FCC Class II Permissive Change Application Letter

Product name : HDMI Wireless Extender
FCC ID: 2ADXC-QAZWSXRX
Date of Grant: 01/02/2025
Model No.: LKV699KVM-V2.0-RX, LKV699-V2.0-RX, LKV677-V2.0-RX,
LKV677KVM-V2.0-RX, LKV655-V2.0-RX, LKV655KVM-V2.0-RX

Change Contents: Replace the casing and only derive one prototype:

Location	Old PCB of FCC ID: 2ADXC-QAZWSXRX	New PCB of FCC ID: 2ADXC-QAZWSXRX
Product Appearance

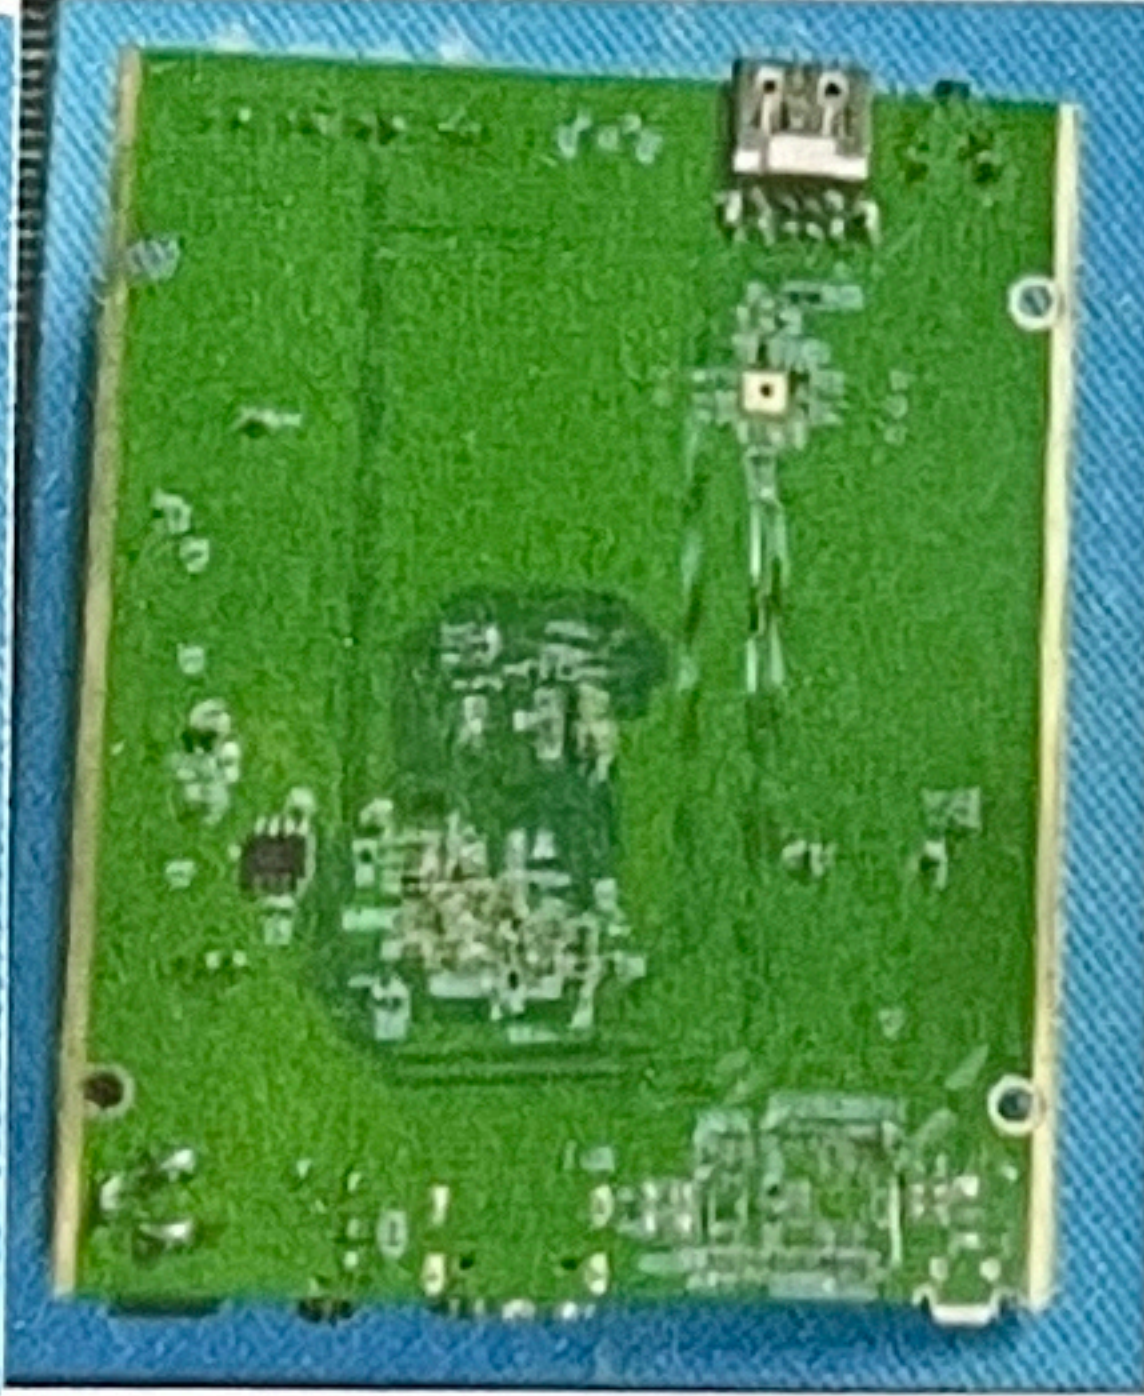
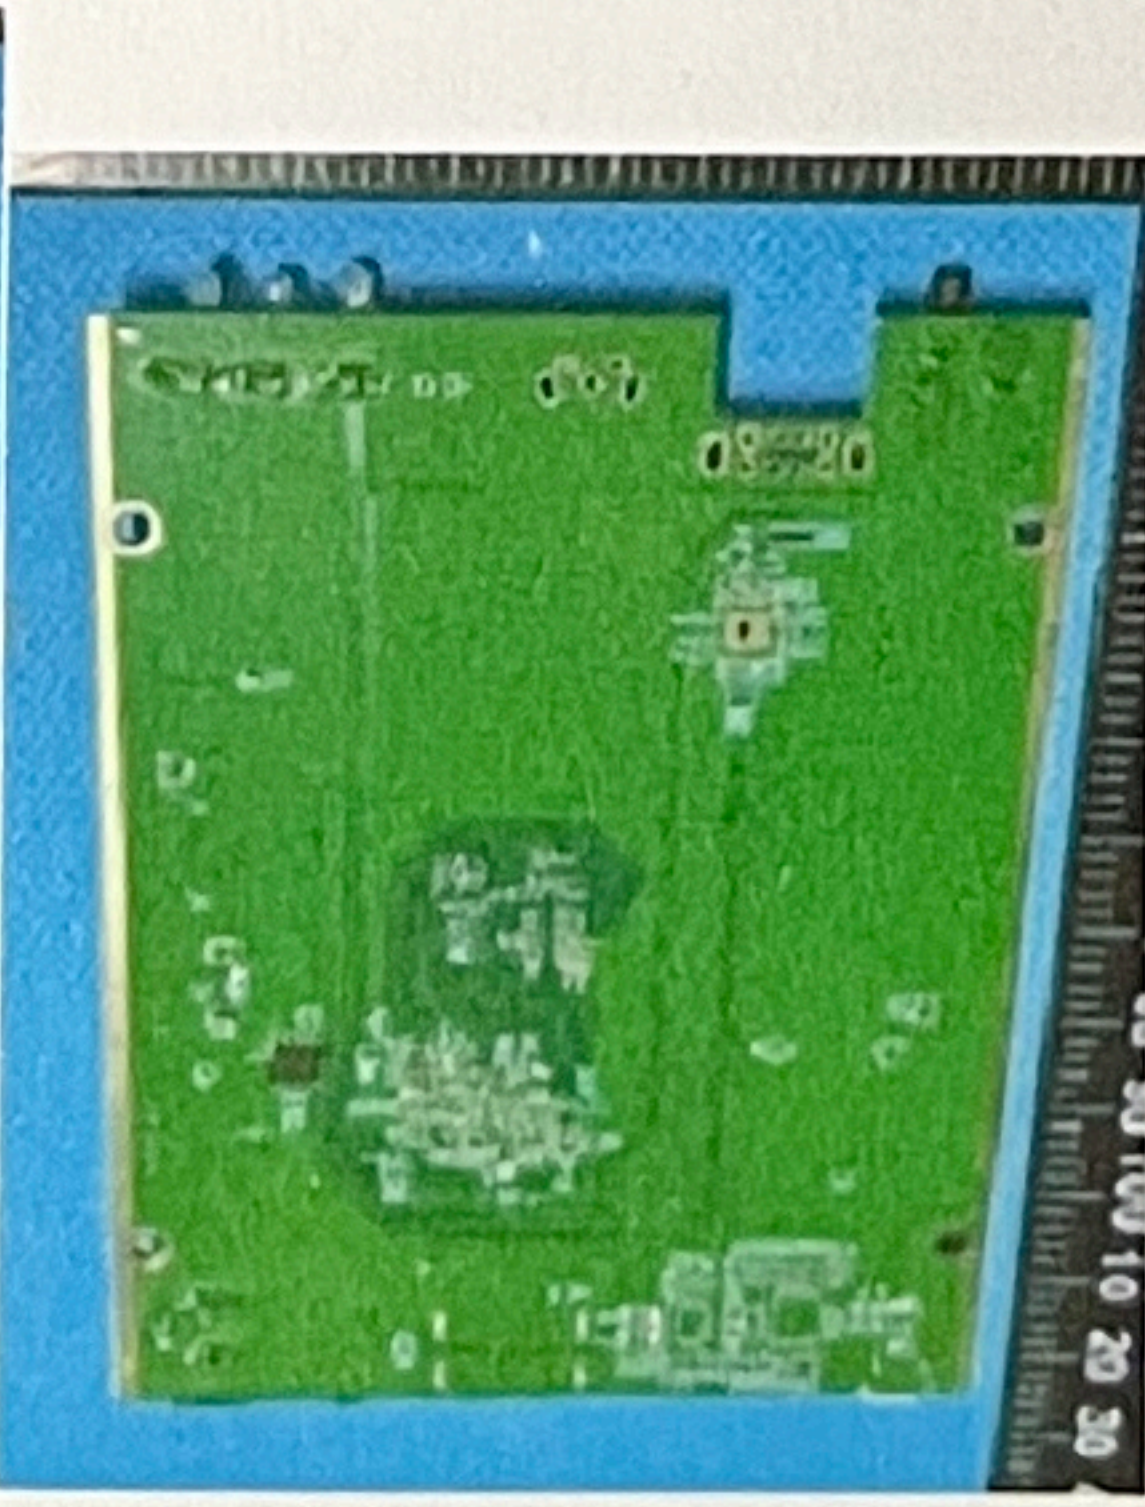
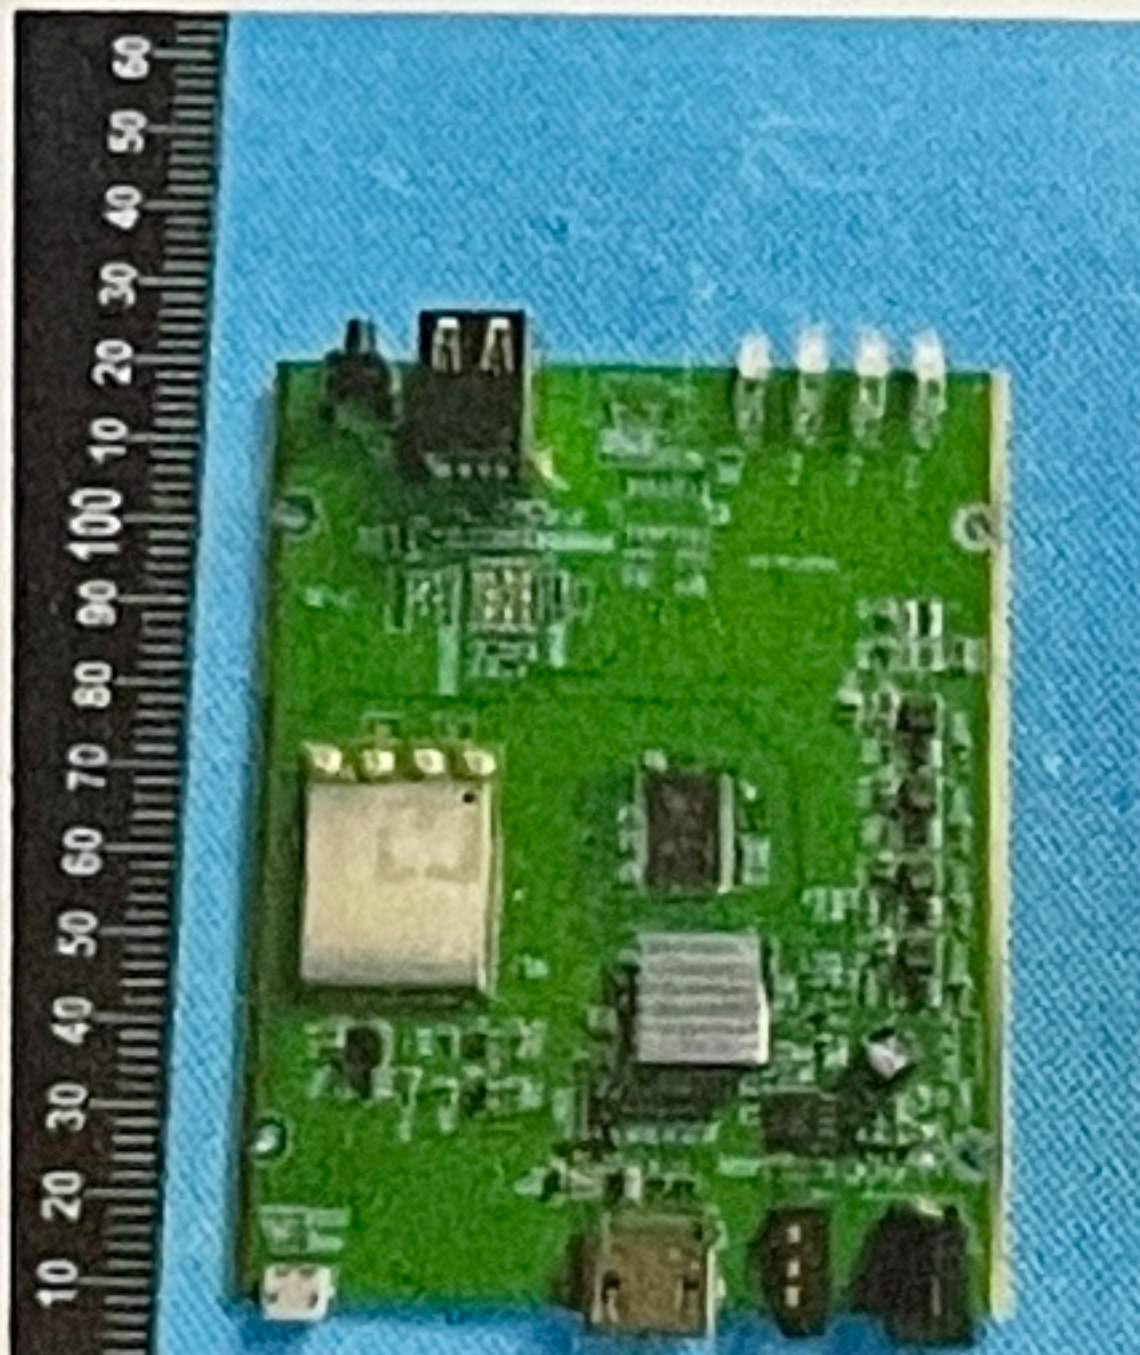
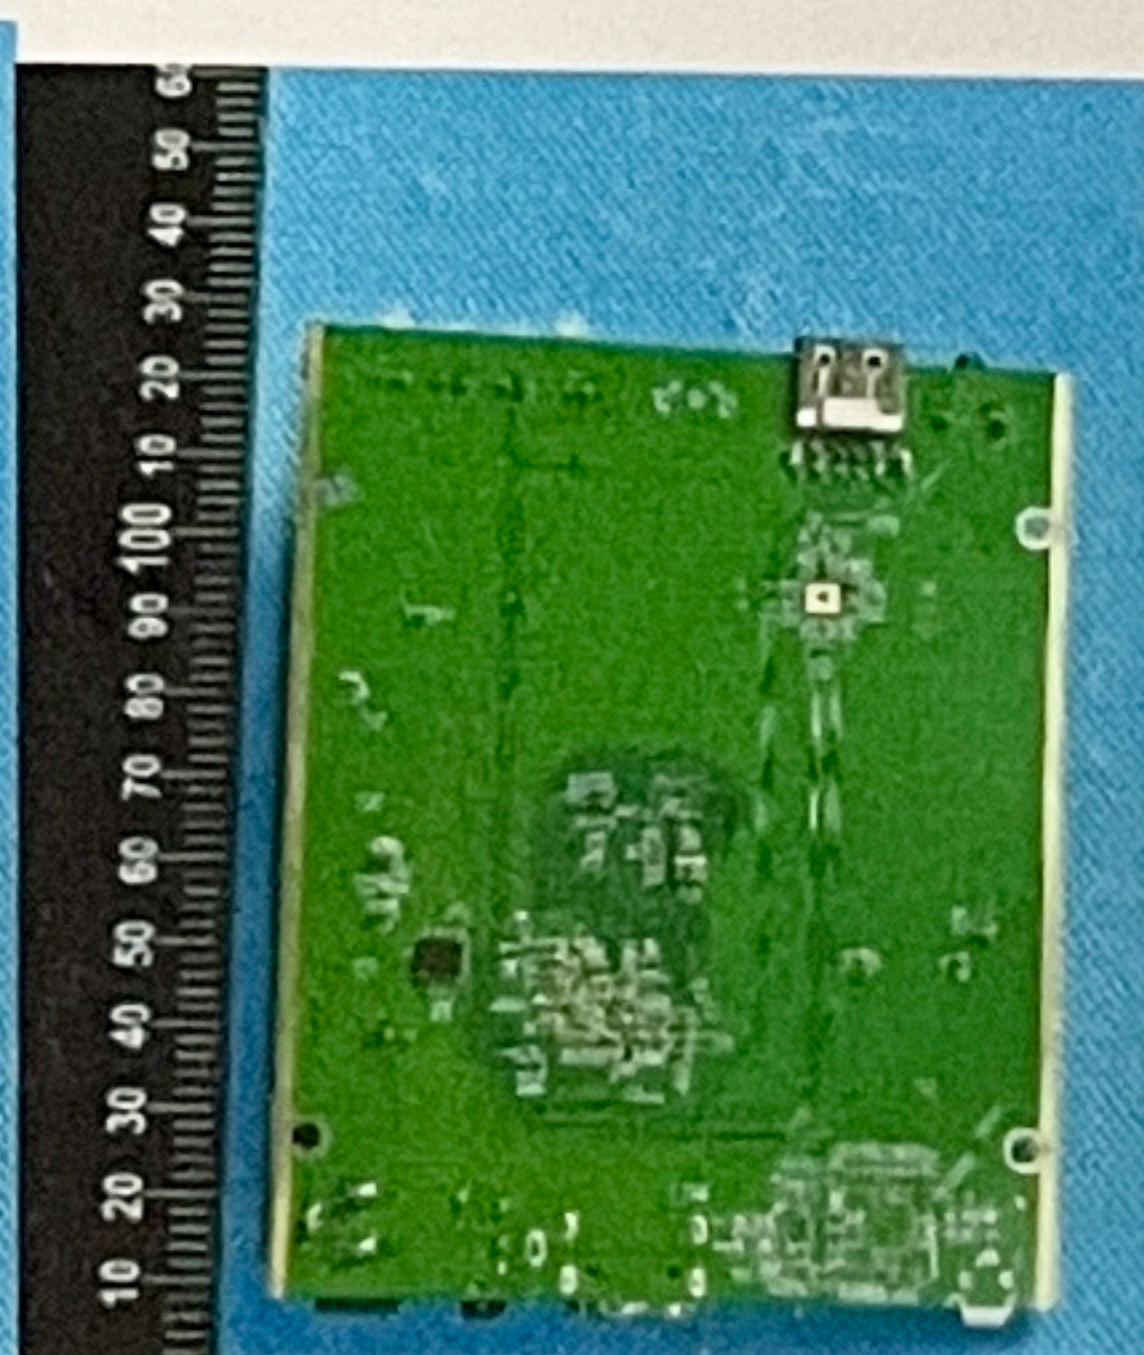
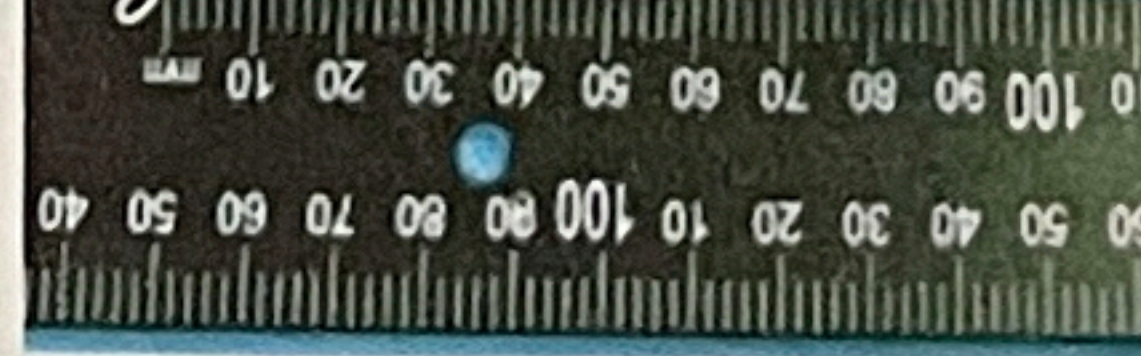
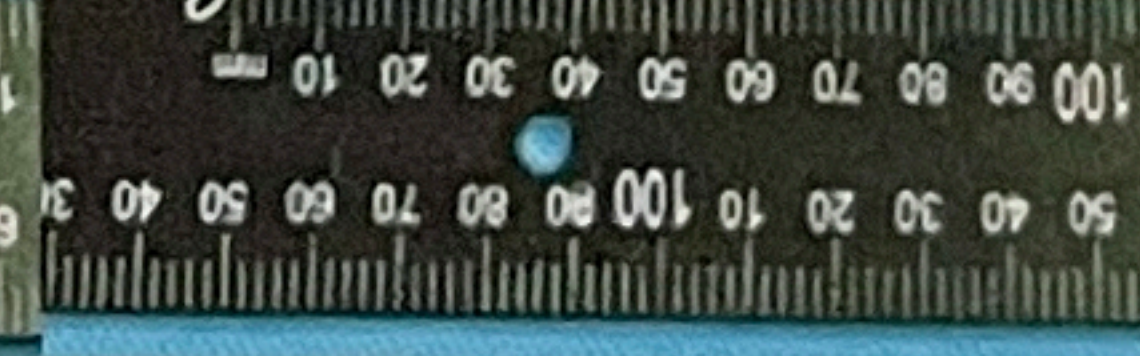
Previously, the shell material was iron, but now it is aluminum. There were originally two PCBA boards, but now there is only one.
Modifications that do not change the fundamental RF characteristics and that do not degrade the unwanted emissions of the certified product, please refer to test report for more details; Modifications that do not change physical characteristics significantly. We attach new photographs to identify the modified product.
